From: [Sean Noonan](#)
To: [Edgar Gonzalez](#)
Subject: Comment on IS/MND for Tentative Tract Map 20637 (TT23-00004)
Date: Wednesday, February 18, 2026 4:03:47 PM

Tentative Tract Map 20637 (PROJECT)
 MITIGATED NEGATIVE DECLARATION (MND)
 SCH# 2026020360

Subject: The draft Initial Study and Proposed Mitigated Negative Declaration for Tentative Tract Map 20637 (TT23-00004) SCH# 2026020360

SHEET NO. 235
 DRAWING NO. N-29C91-30

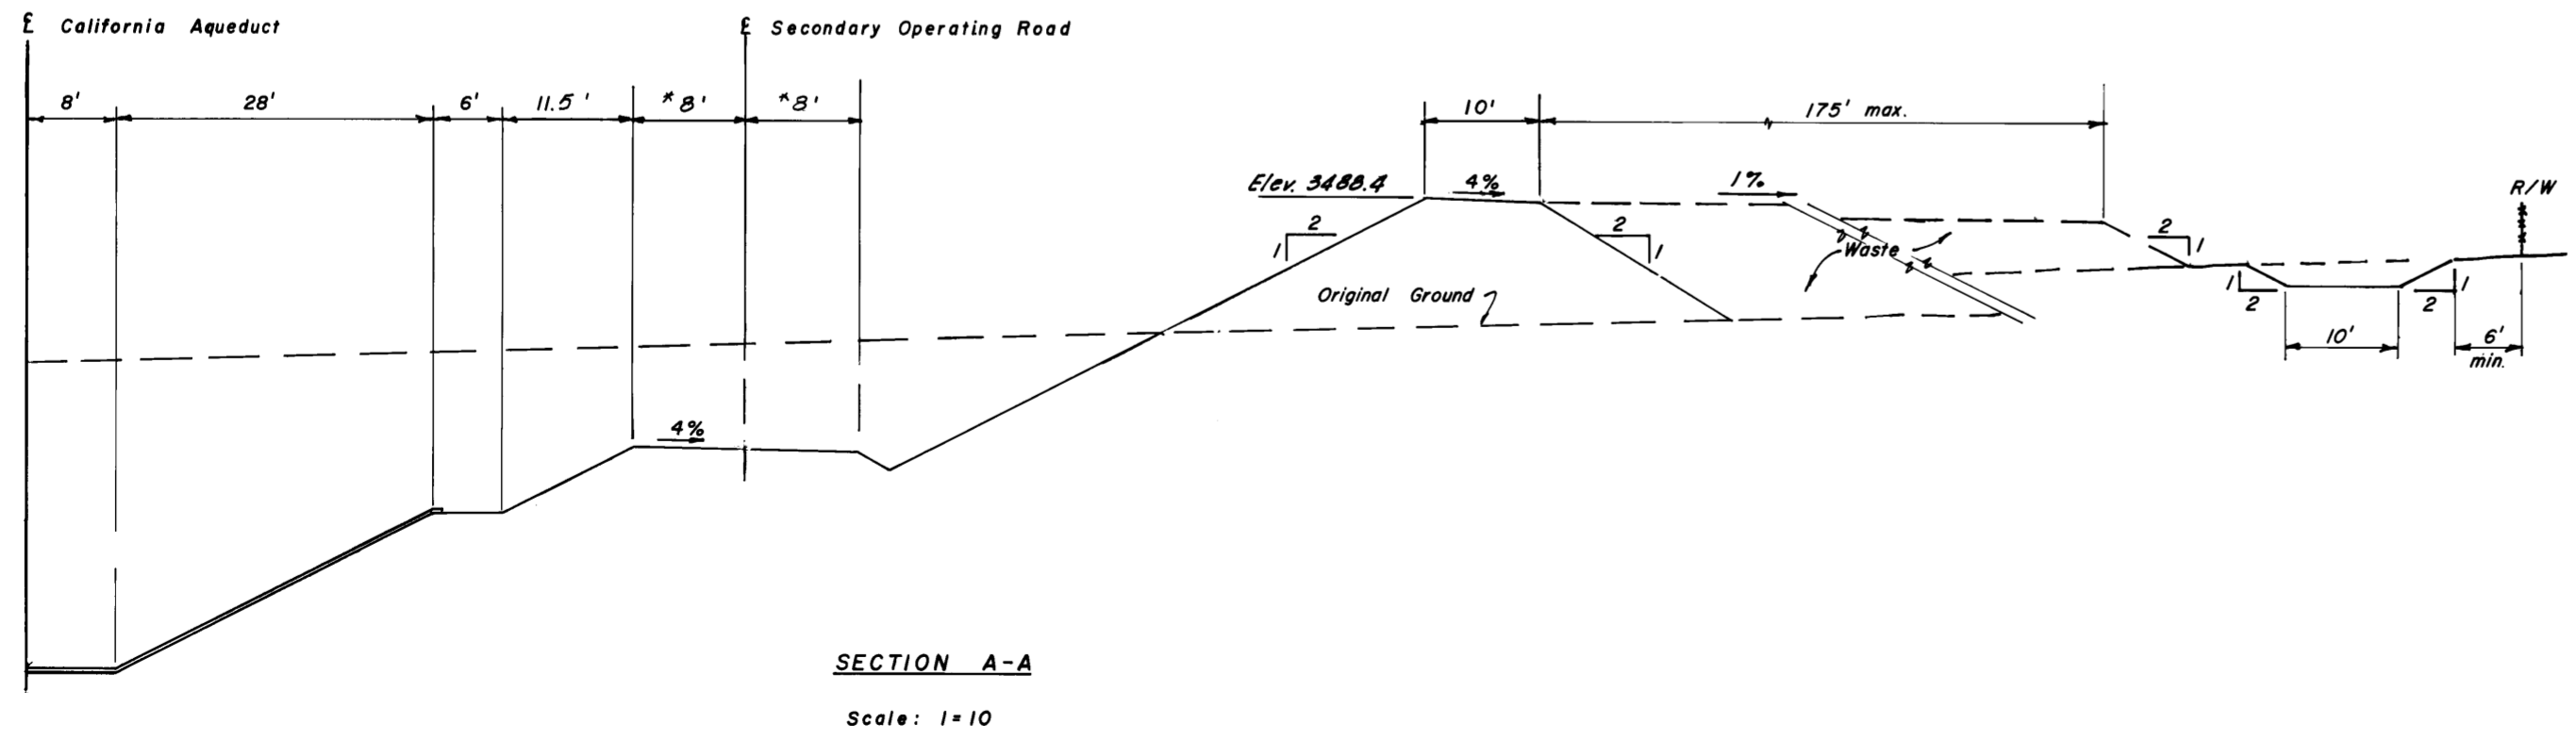
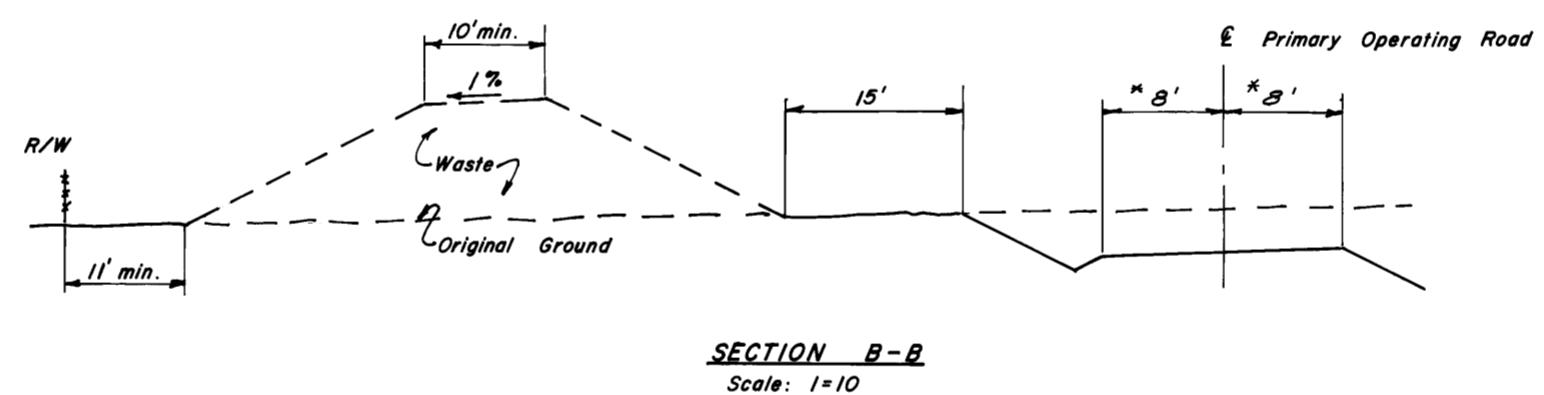
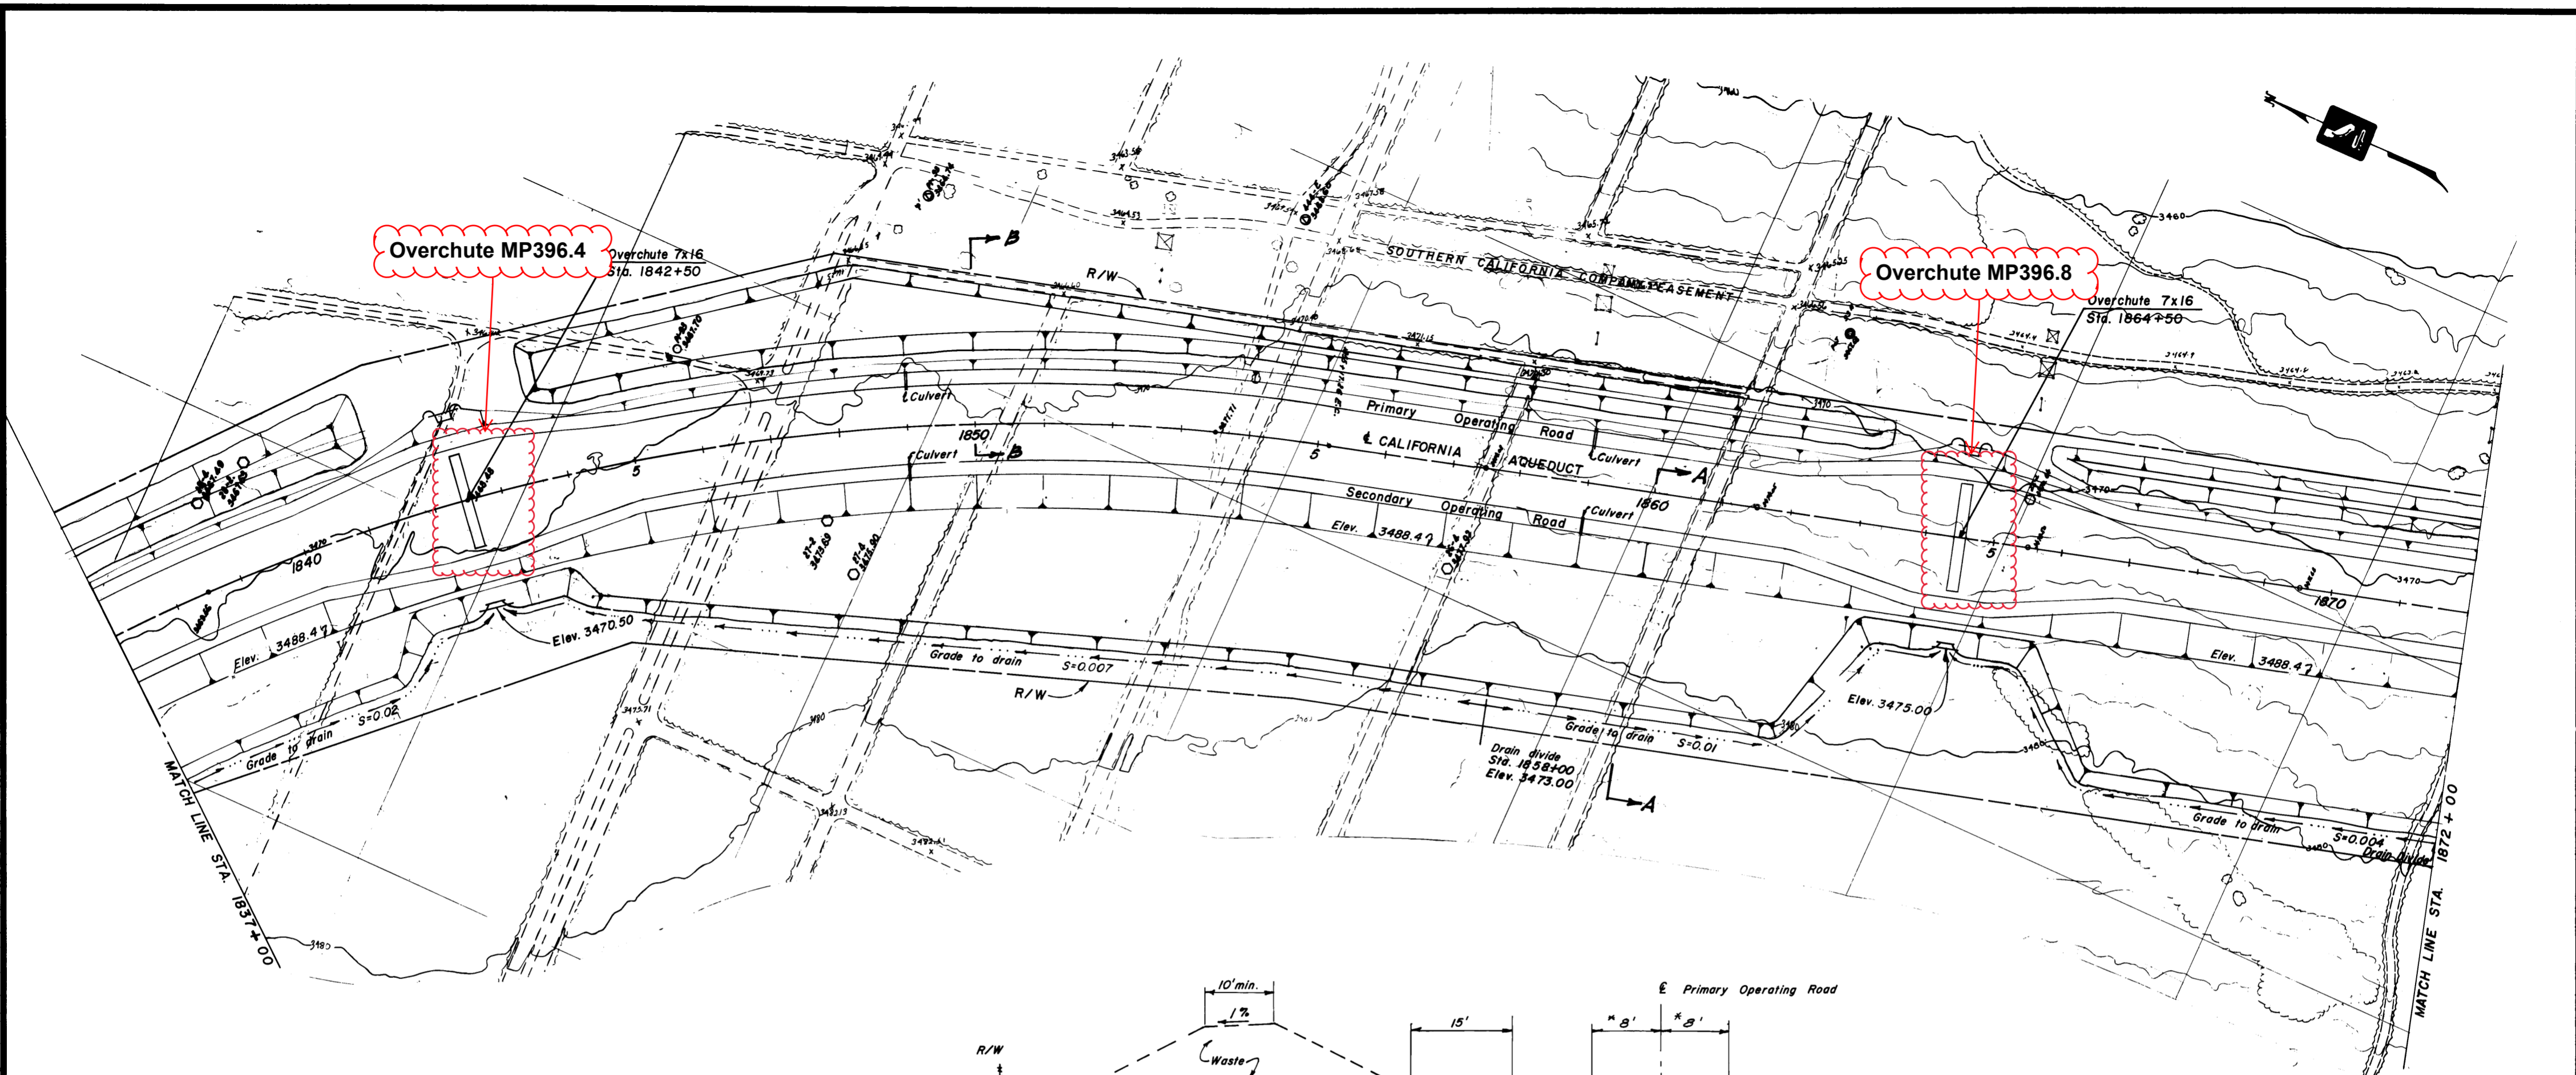
1. MP396.1 Overchute crossing over the Aqueduct located at the north end of Fuente Ave. See attached DWR As-built Drawing No. N-29F1-17, N-29C22-1, N-29C91-30.
2. MP396.4 Overchute crossing over the Aqueduct located at east end of Sultana St and DWR right of way west boundary. See attached DWR As-built Drawing No. N-29F1-18, N-29C24-1, N-29C91-31.
3. MP396.8 Overchute crossing over the Aqueduct located at east end of Pinellia St and DWR right of way west boundary. See attached DWR As-built Drawing No. N-29F1-18, N-29C23-1, N-29C91-31.

4. Drainage Ditch along DWR right of way west boundary which conveys runoff flows into the Overchutes listed above. The earthen drainage ditch measures 10 feet wide at bottom with 2 to 1 side slopes. See attached DWR As-built Drawing No. N-29C91-30 and N-29C91-31.
5. Drainage Basin located at east end of Mayapple St which drains into DWR MP396.8 Overchute through concrete lined channel.

**SWP CROSS DRAINAGE
EAST BRANCH
Mile Post 303.9 to Mile Post 403.4
HYDROLOGIC & HYDRAULIC DATA
TABLE B-9**

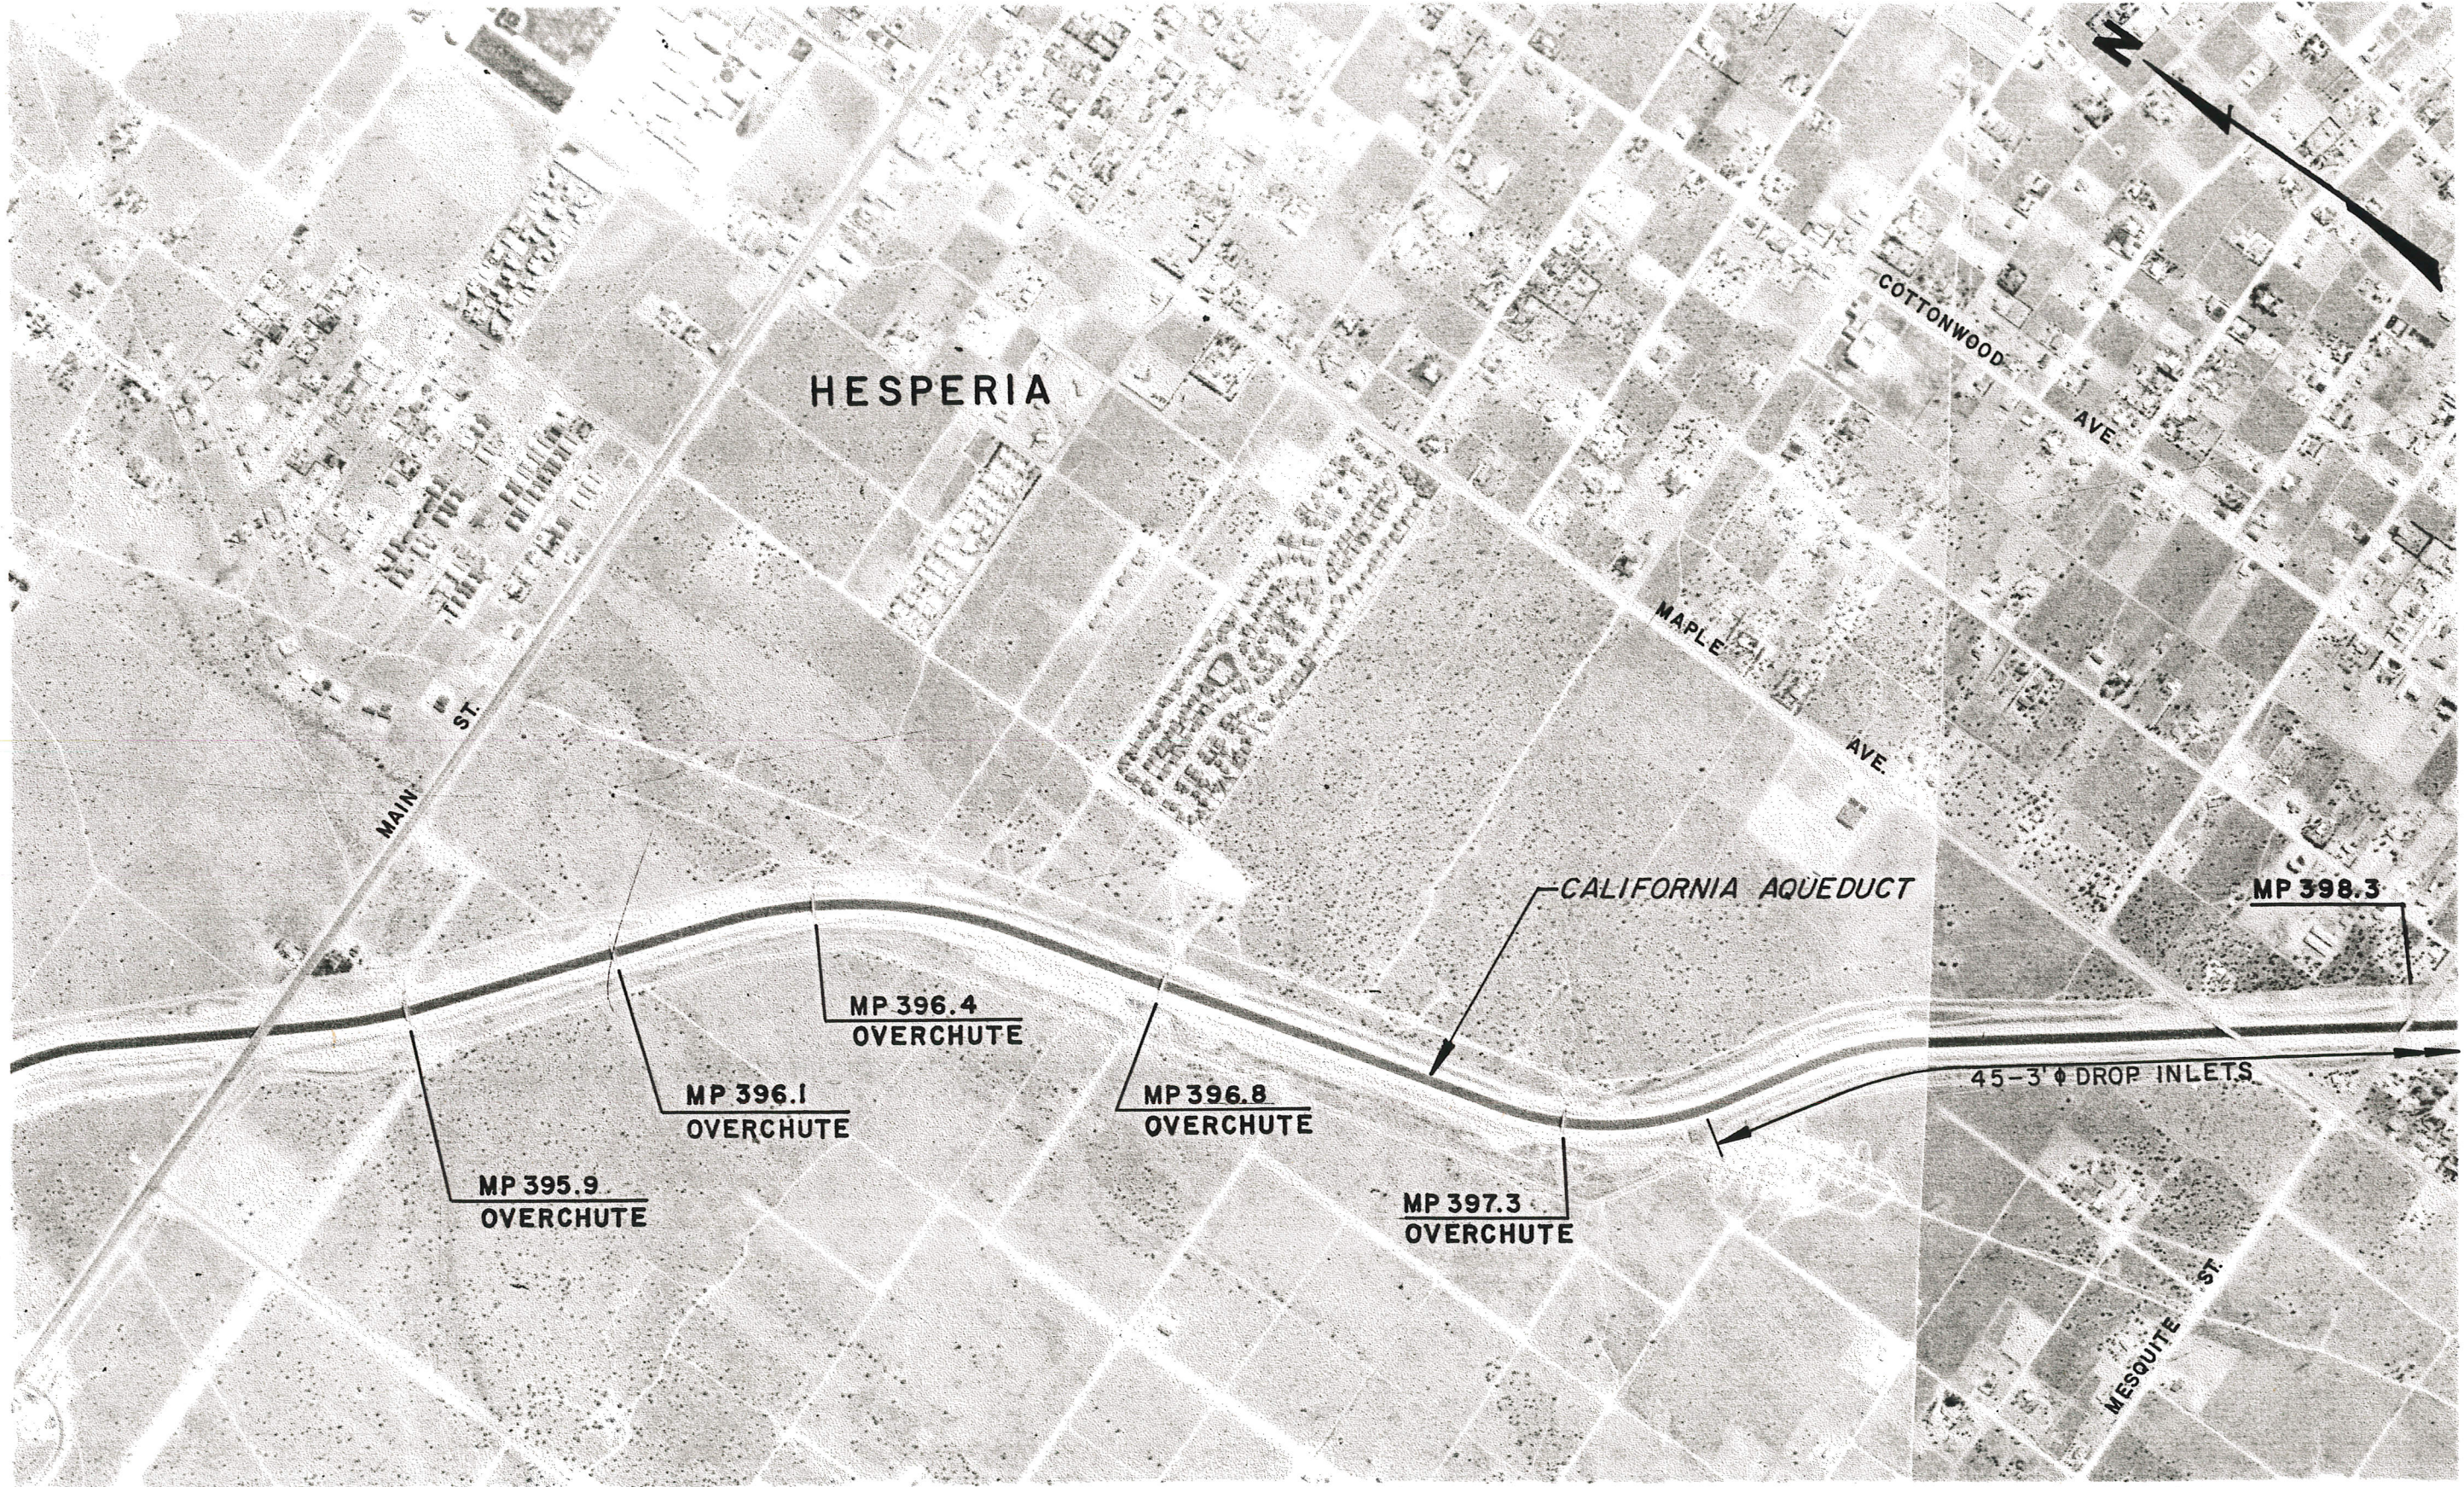
See attachment for DWR Hydrologic & Hydraulic Data which shows the structural capacities (cfs) of all the DWR Overchutes listed above. Hydrology and Drainage Analysis for proposed development is also needed to assess the flows (cfs) and flow velocities through DWR Overchutes to determine if energy dissipation structures or any improvements are needed on the inlet side within DWR right of way to prevent erosion.

2. The applicant shall provide hydrology/drainage study or report for this proposed development showing the pre and post developments impacts to DWR right of way.
